Joint IEEE P802.3ct / P802.3cw Task Force Interim Teleconference

Supporting Material for Consensus - Comments R1-9, R1-48, R1-50, R1-53, R1-54

04 February 2021

Figure 154-3—Black link example configuration for specifying n DWDM channels

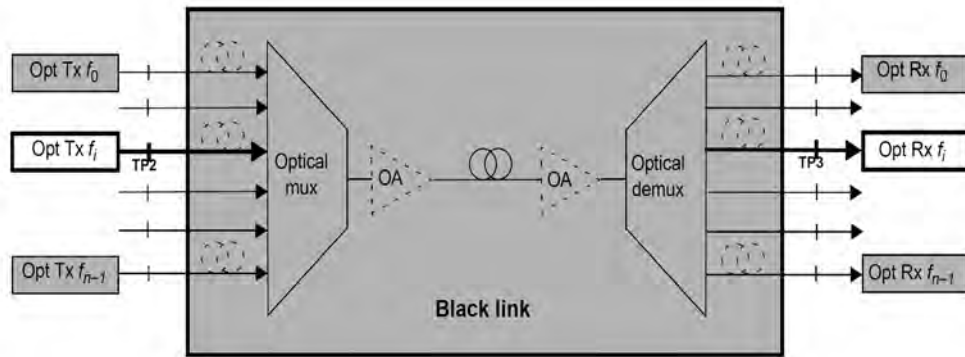
- Current Figure 154-3 is an example of an implementation, but a more general figure, not showing an implementation, would be more appropriate

Suggestion Regarding Fig 154-3 (R1-54)

- The focus of this figure is when all signals are propagating on a single fiber in the same direction

For clarity, only one direction of transmission is shown
Figure 154-3 – Black Link Approach for specifying DWDM channels in a DWDM Link

Figure 154–3—Black link example configuration for specifying n DWDM channels

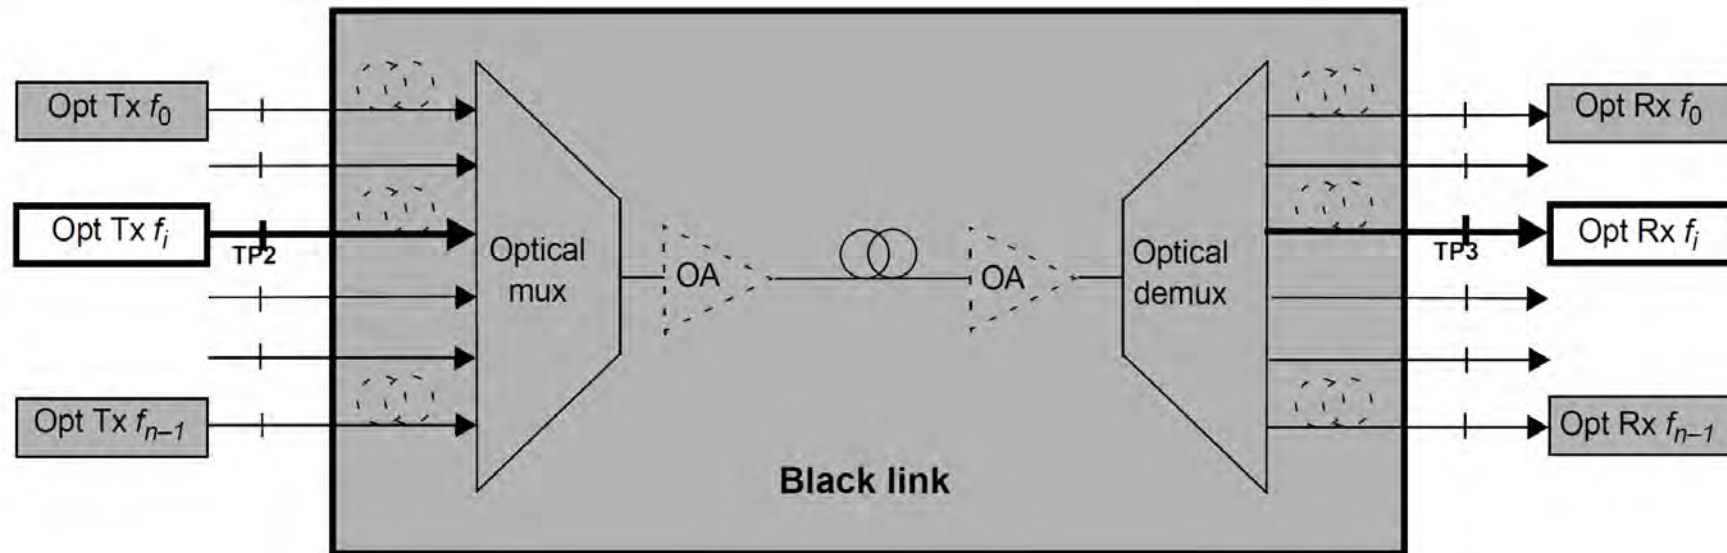
Example Implementations should be placed in Annex 154A

- If this figure is kept, need to add note – “For clarity, only one direction of transmission is shown.”
- Change “Black link” to “DWDM link” in figure and title
- Change title to “DWDM link example configuration”

Proposed Annex 154A Example Configuration Figure Single Fiber Per Direction

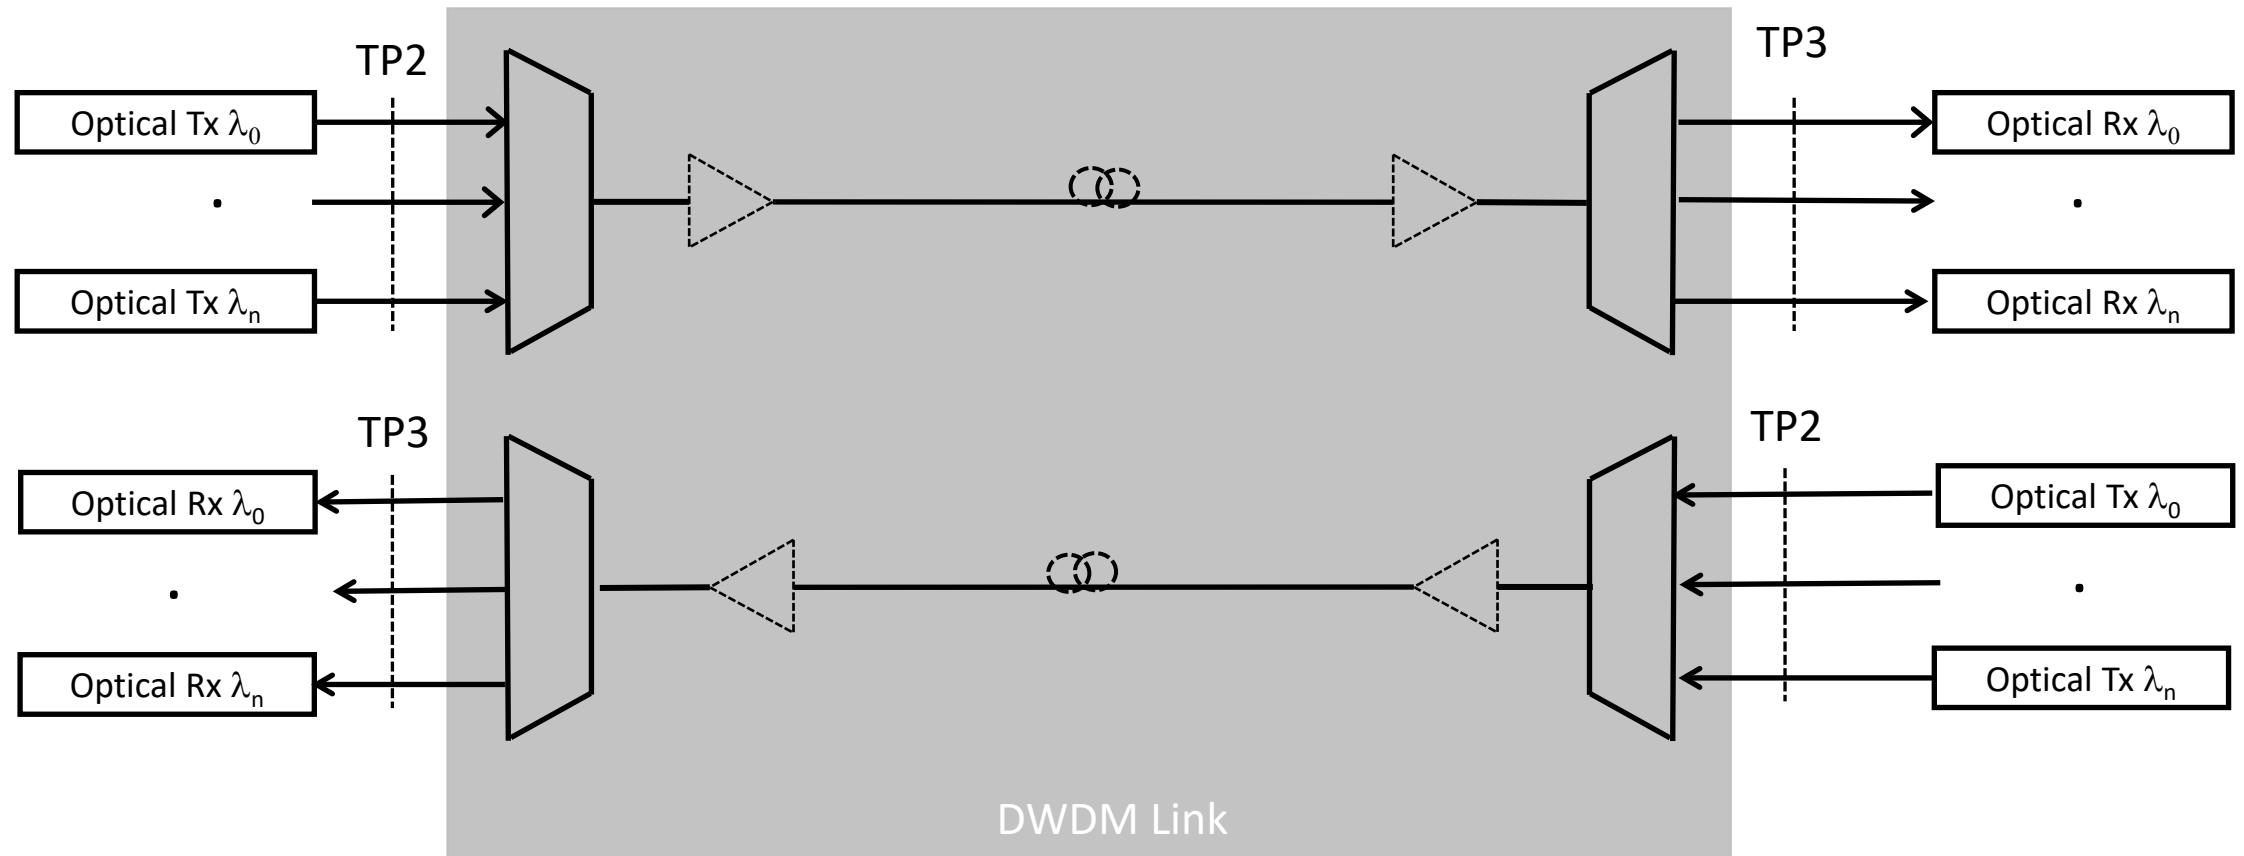
Example - DWDM Link – Single Fiber Per Direction

Proposed Annex 154A Example Configuration Figure to Address Single Fiber

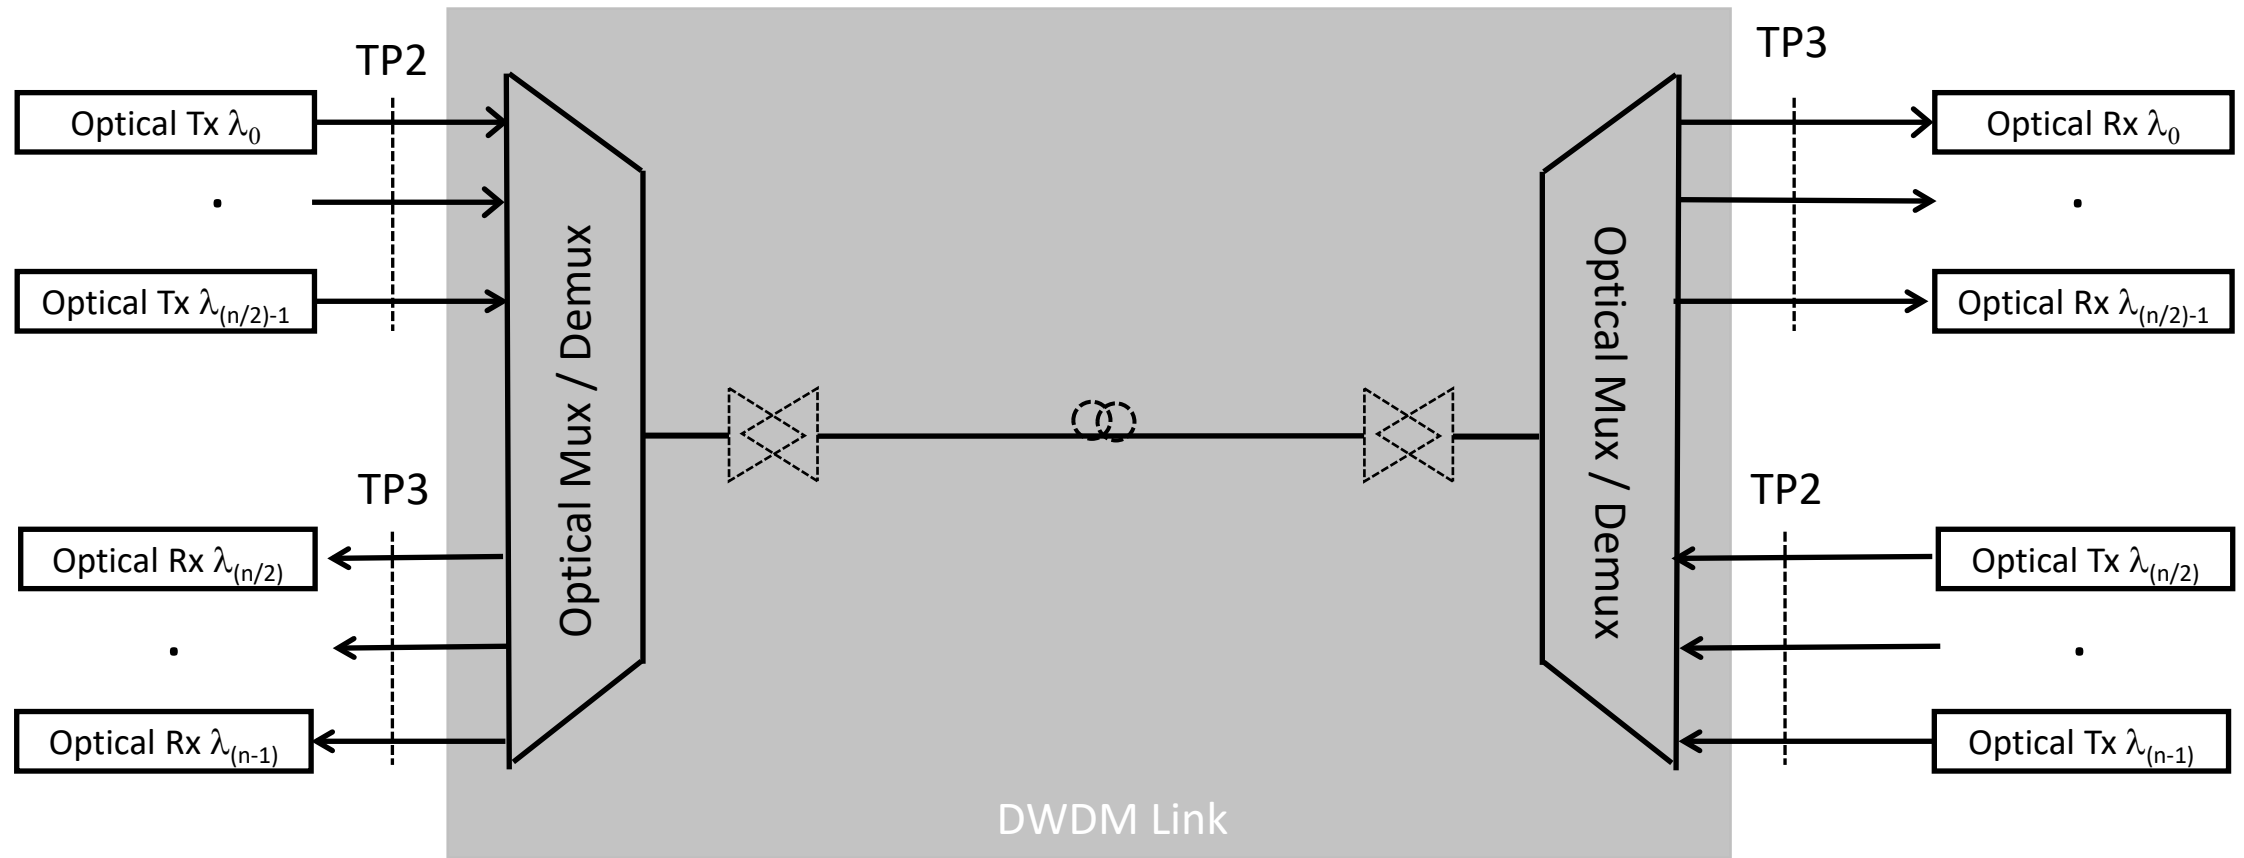
Example - DWDM Link – Single Fiber

Based on ITU-T G698.2 Figure 5-3 – Linear "black link" approach for bidirectional applications
